TO: Mayor Rochelle Robinson, City of Douglasville
ATTN TO: Shayla Reed, Community Development Director, City of Douglasville
FROM: Mike Alexander, Director, ARC Center for Livable Communities
RE: Development of Regional Impact (DRI) Review

Name of Proposal: *Emblem Riverside Phase II DRI 3603*

DRI MASTER SITE PLAN

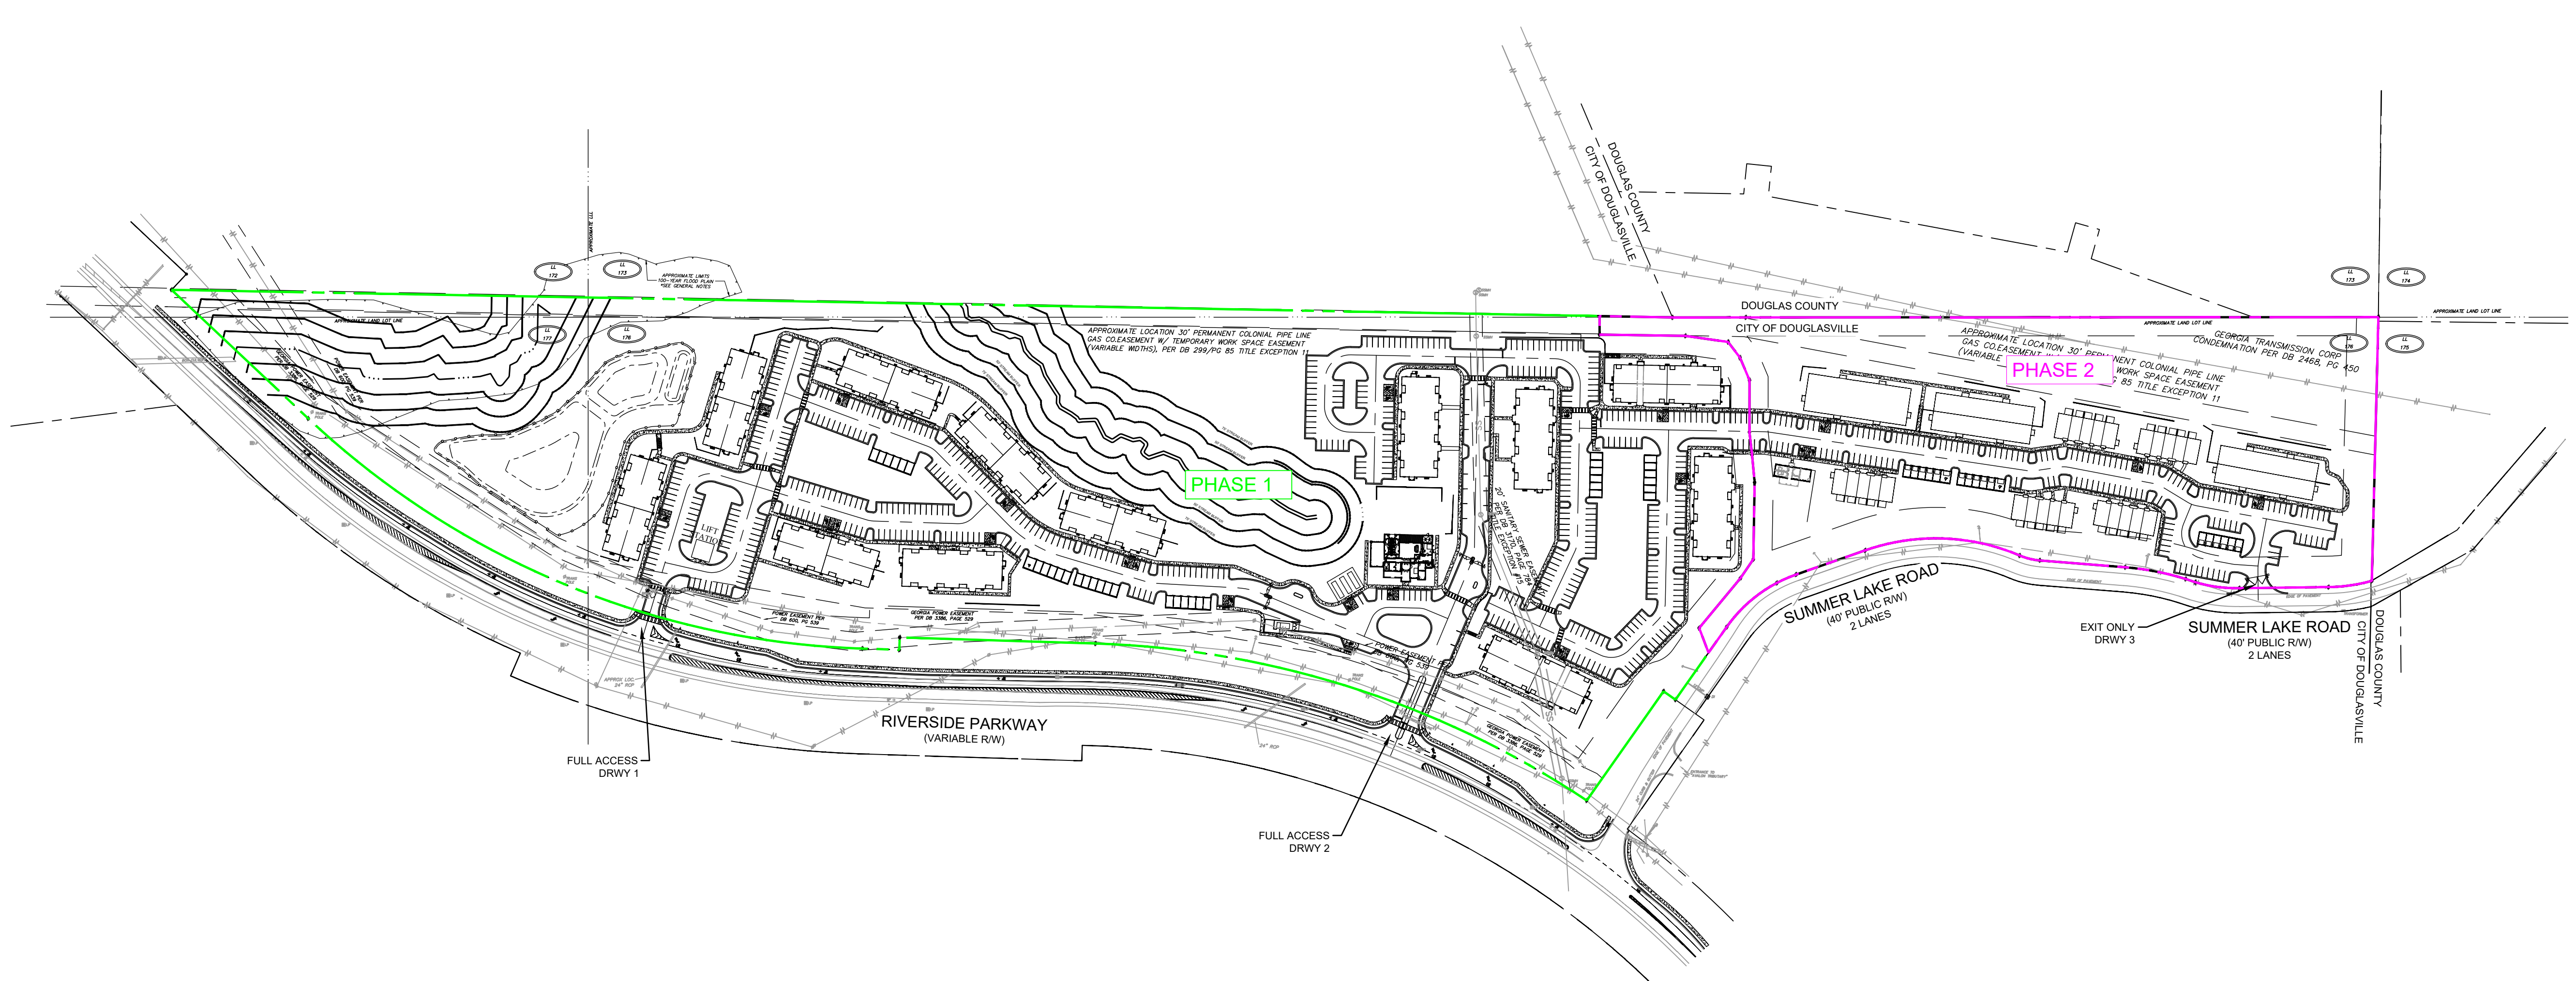
Project elements appear to avoid intrusions into stream buffers which is strongly supportive of regional water quality and environmental protection policies.

The project includes a comprehensive internal sidewalk network connecting to proposed sidewalks and bike lanes on Riverside Parkway which is consistent with regional transportation goals and recommendations.

A total of 795 parking spaces are proposed but no EV charging stations are included; provision of some EV charging stations would be consistent with regional efforts to develop EV infrastructure.

Care should be taken to ensure that the constructed development provides an interconnected, functional, clearly marked and comfortable pedestrian experience on all driveways, paths, entrances, and parking

areas. To the maximum extent possible, new driveways and intersection corners where pedestrians will cross should be constructed with minimal curb radii to reduce speeds of turning vehicles and decrease crossing distances for pedestrians.

Both the USGS coverage for the project area and the project site plan show an unnamed blue-line stream in the Phase I portion of the property. The site plan shows and identifies both the 50-foot undisturbed stream buffer and additional 25-foot impervious setback required under the City's Stream Buffer Ordinance, as well as the State 25-foot State Erosion and Sedimentation Control buffer along the entire length of the stream on the property. No intrusions into the buffers are shown on the site plan. Any buffer intrusions that occur during construction may require variances from the appropriate agency. Any unmapped streams in either phase of the project may also be subject to the City buffer ordinance. Any other State waters identified on the property may also be subject to the State 25-foot Sediment and Erosion Control buffer.

Retention of additional natural wooded areas or greenspace wherever possible on the site would be in keeping with regional policies regarding water resource protection, carbon sequestration and heat island mitigation.

The project can further support The Atlanta Region's Plan by incorporating other aspects of regional environmental policy, including green infrastructure and/or low-impact design, e.g., pervious pavers, rain gardens, vegetated swales, etc., in the large surface parking areas and site driveways, and as part of any improvements to site frontages.
